APPENDIX B - Design Response

Victoria Quarter, New Barnet

SNB Response October 2021

SNB Design Appraisal Response Scheme Development

Site Constraints Diagram - DAS Extract p22

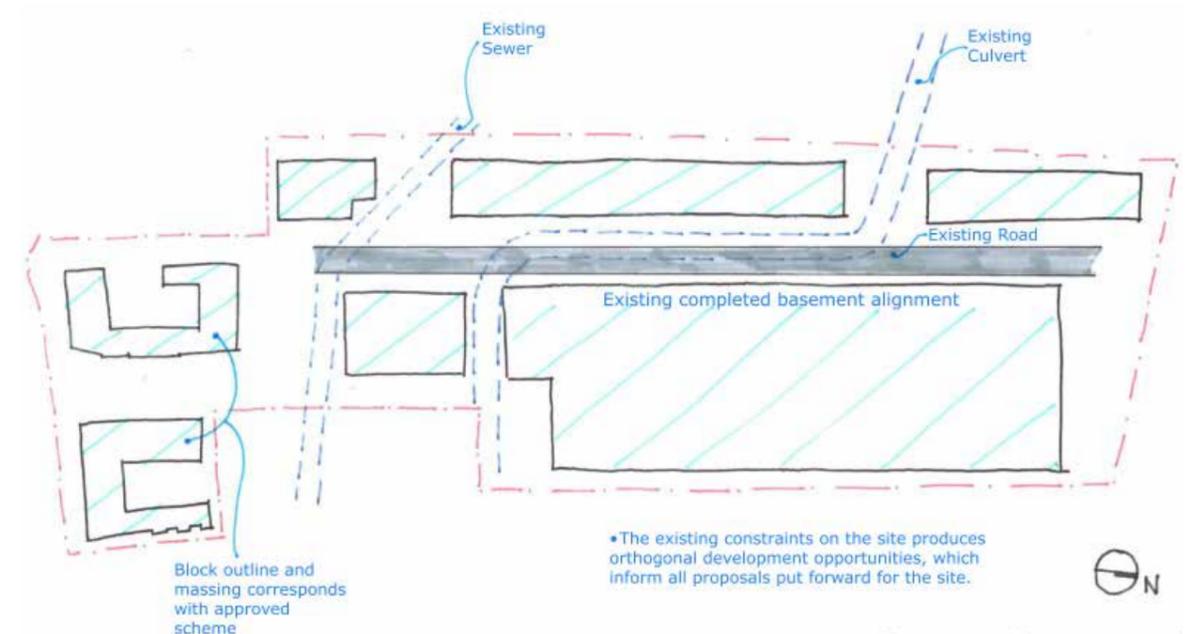
APPARENT MARGINAL AMENDMENTS

Whilst on first impressions the overall appearance of the revised masterplan appears broadly similar to the previous application, contrary to SNB's observations we believe we have made a series of significant improvements to the design, in respect of its layout, massing and material appearance despite restrictions imposed by the sites existing constraints.

- p22 DAS - Diagram clearly demonstrates that when each of the existing physical constraints are taken into account it produces an orthogonal development framework, which heavily influence the geometry proposals considered for the site.
- The Design Development chapter of the DAS (4.0) outlines the various permutations explored and interrogated by the team, however after much debate and analysis the basic framework was considered to be the most successful, when taking all constraints into account. This approach has also been validated by an external third party design review of the proposals.
- We do not consider the significant changes proposed to the separation distances (p62 Design Proposals/DAS) and significant changes to the building typologies, massing and modeling of form to be 'marginal' as described by SNBG. A minimum separation distance of 20m is now achieved to all buildings.

The diagram opposite clearly demonstrates that when each of these physical constraints are taken into account it produces an orthogonal development framework, which will heavily constrain proposals considered for the site.

View towards Building A

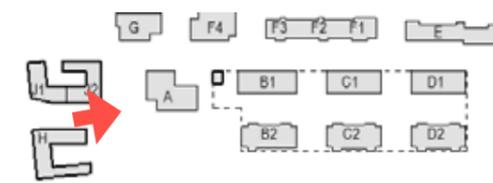
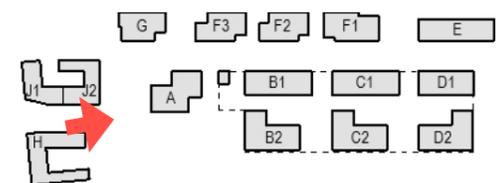
SNB Comment:

“Poor Layout: No change in the underlying design strategy as a consequence many of the design issues in the refused scheme still remain in the new proposals.”

The following images demonstrate the significant changes made to the layout and overall masterplan, to improve the massing arrangement, the improved modelling of the building forms to respond to their context, improved separation distances and visual permeability within the scheme.

- Previously 7/10 storeys; Block A has reduced in height . The arrangement of 5No: storeys aligns with the lower massing of Block G/J providing a mediating volume to the 7No: storey element fronting the Park Plaza.
- B2 massing in the distance has reduced to facilitate an extended view through the site

Illustrative Masterplan

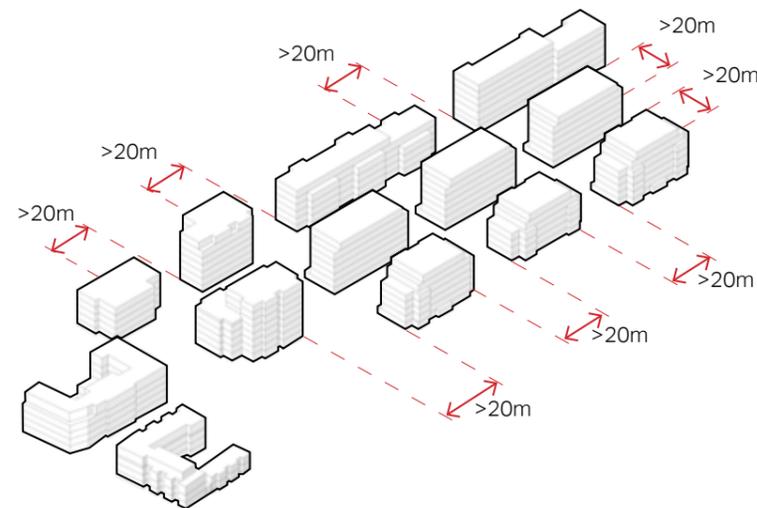
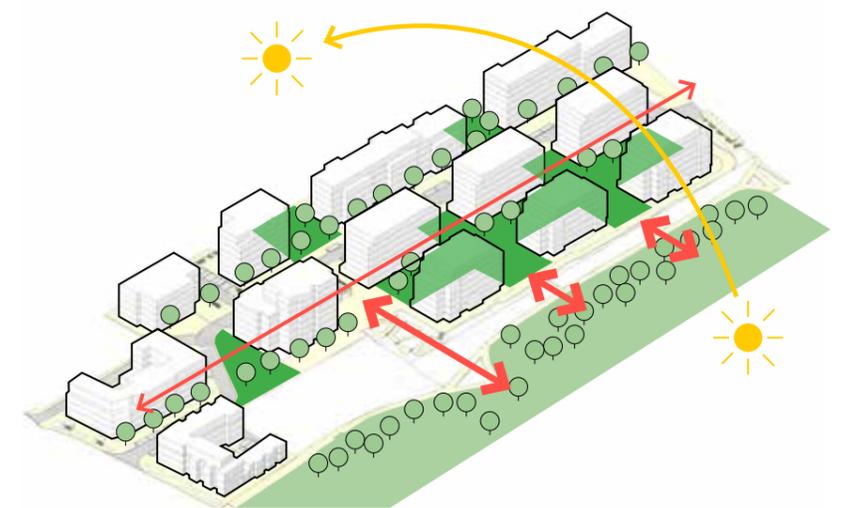
SNB Comment

“Poor Layout: No change in the underlying design strategy as a consequence many of the design issues in the refused scheme still remain in the new proposals.”

In settling on the proposed layout the design team explored and analysed numerous layouts for the site. It was only after this exercise had been exhausted and discussed at length with Barnet planning officers that the Design team progressed the eventual proposal. (see option studies DAS pages 30-34).

Whilst on first impressions the pattern of layout remains broadly similar to the previous application (as a result of the underlying impact of site constraints, the design team has made significant changes to the individual block layouts, massing and modeling of the built form. The comparative 3D studies undertaken by the design team to demonstrate these step changes to the form and layout. (see studies in DAS 4.10 p40 – 45)

The proposal has been specifically designed to address the perceived shortcomings identified in previous application. As such we have addressed and improved the following:

- Achieved minimum separation distances between buildings of 20m.
- Improved the aspect of many of the units and improved daylight within the courtyard and other amenity spaces.
- Increased permeability within the masterplan, improving physical and visual connectivity to the Recreation Ground
- Increased quantum of amenity space
- Improved ratio of dual aspect units (382 No: units at 70.2%)
- Reduced building heights within the masterplan – Building A reduced to 7No: storeys, with the remaining buildings ranging from 4-7 storeys.
- Increased variety to the elevational treatments of buildings within the masterplan

PERMEABILITY

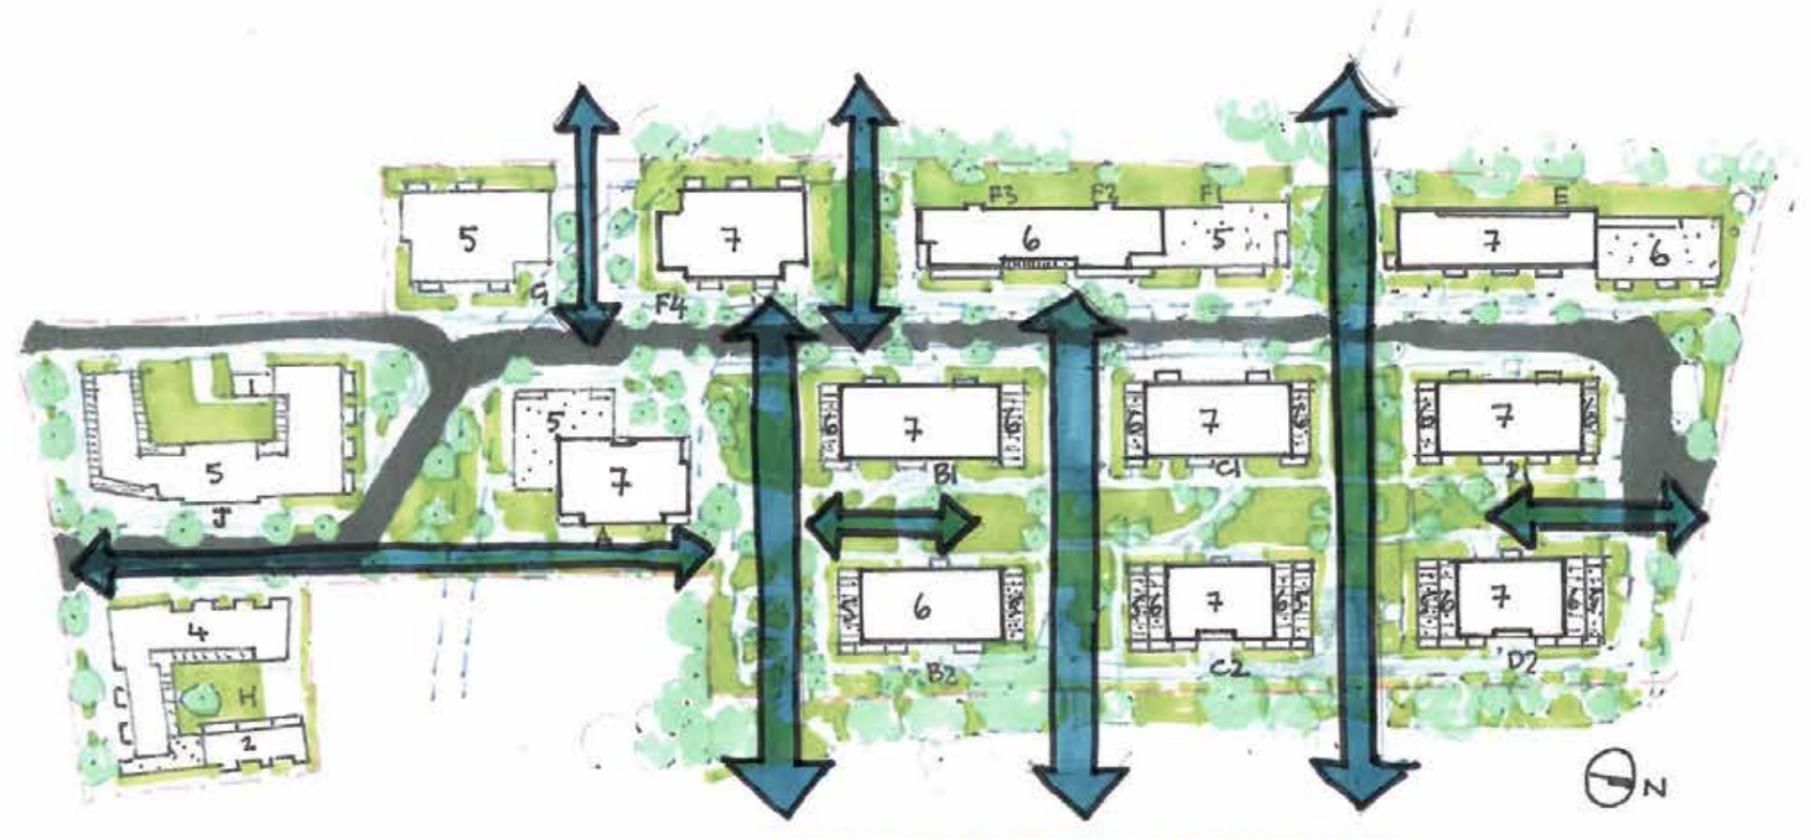
“5.3 Lack of permeability and blocked views detract from the ‘legibility’ of the site

The site layout, orientation and design of individual dwellings ... should be orientated to optimise opportunities for visual interest through a range of immediate and longer range views, with the views from individual dwellings considered at an early design stage (London Plan)

- Section 5.8 of the DAS illustrates the high level of both visual and physical permeability within the masterplan. The layout promotes views through the masterplan and connects the neighbourhood to the Recreation Ground.
- The visual material demonstrates the legible yet permeable nature of the masterplan.

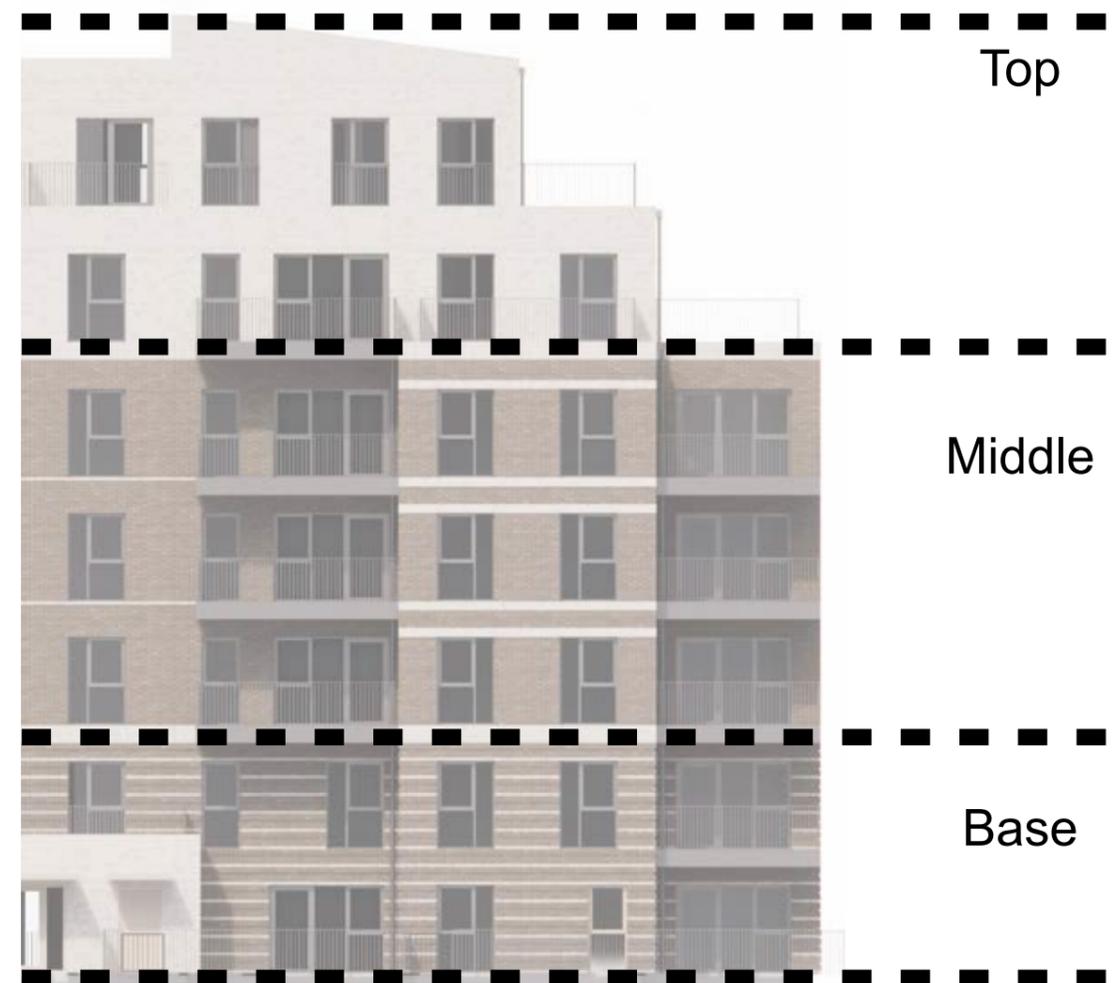
SNB Comment:

“...the architect for the proposed scheme appears to have left detail design to the final stages of the design process. Detailing considered in isolation like this and stripped to a minimum merely reinforces the uniform blandness of the scheme.”

Contrary to the SNB criticism, the detail design has been considered, developed and integrated at the earliest stages of the design process, as the architectural development of the built forms have developed from a consistent overarching narrative. There is a consistency to the approach which runs through the buildings modelling/massing through to it’s detail, ensuring that the buildings present a complexity and quality in both long and close views.

The following pages provide an insight into the complexity of building form, tonal contrast and texture which we believe undermines SNBs criticism.

Hierarchy and proportion will be explored within this scheme to generate a rich architectural language. Additionally, quiet contemporary brick detailing will occur throughout to give visual depth to the buildings as well as sophistication.
